**QUESTIONS-ANSWERS-CLARIFICATIONS**  
**COMMUNITY CENTER SECURITY CAMERA PROJECT**  
**PROJECT NO. CR23005**

**Questions & Answers No. 3 – May 2, 2023**

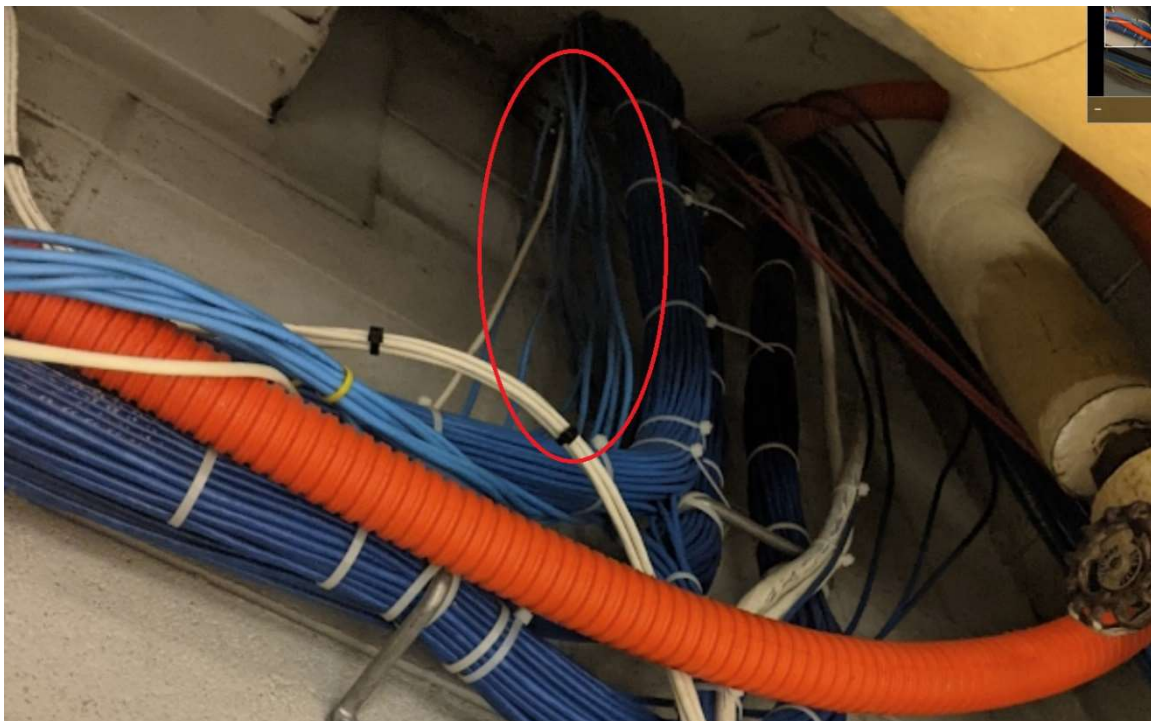
These systems are most likely to have a browser-based front end/portal. The systems must be able to keep up with browser-based security requirements that will continuously need to be updated/upgraded. Trying to avoid systems that are specific browser dependent or the “use this browser because it’s less secure” scenario.

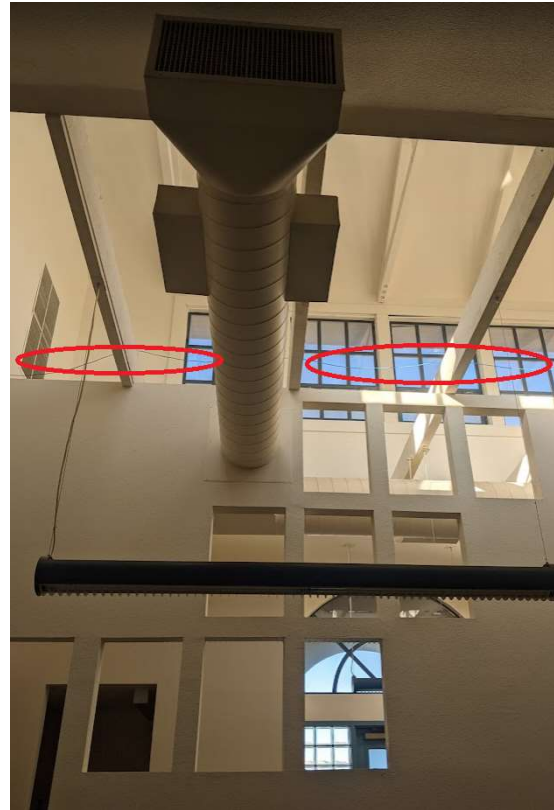
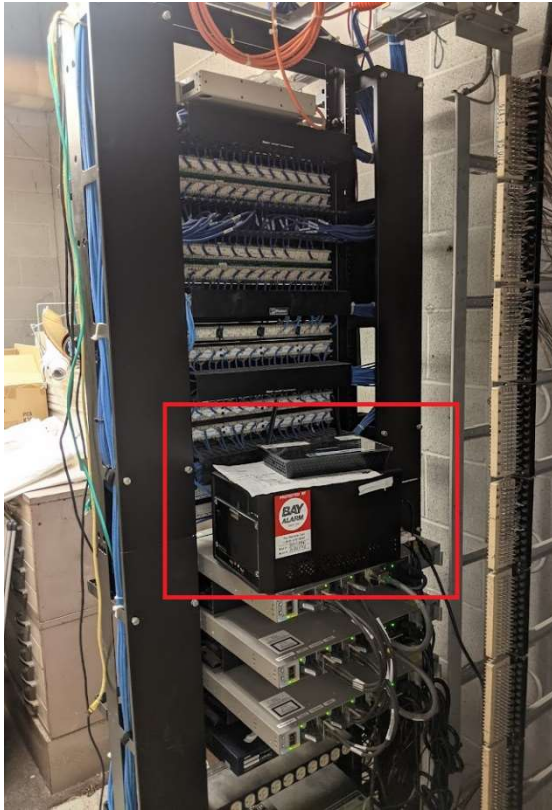
Network cable color and network keystone (jacks) are not necessarily the same color.

Cable Colors – The following is the color standard for all horizontal cable on campus (as of 03/18/2022)

Our primary concern is the keystone (jack) color. Varying the cable color itself helps us trace lines later down the road and sometimes allows us to distinguish between the type (Cat5/5e/6/6a) of cable used for City Network connections at each site.

Purpose	Data / VoIP	Audio / Visual	Security / Cameras	Wireless	Building Automated Systems	Lighting Controls	PA System
Cable Type	Cat 6	Cat 6	Cat6a	Cat 6a	Cat 6	Cat 6	Cat 6
Cable Color	White	White	Green	Green	Gray	Yellow	Gray
Keystone (Jack)	Left – yellow Right - blue	Purple	Red	White	Orange	TBD	Gray
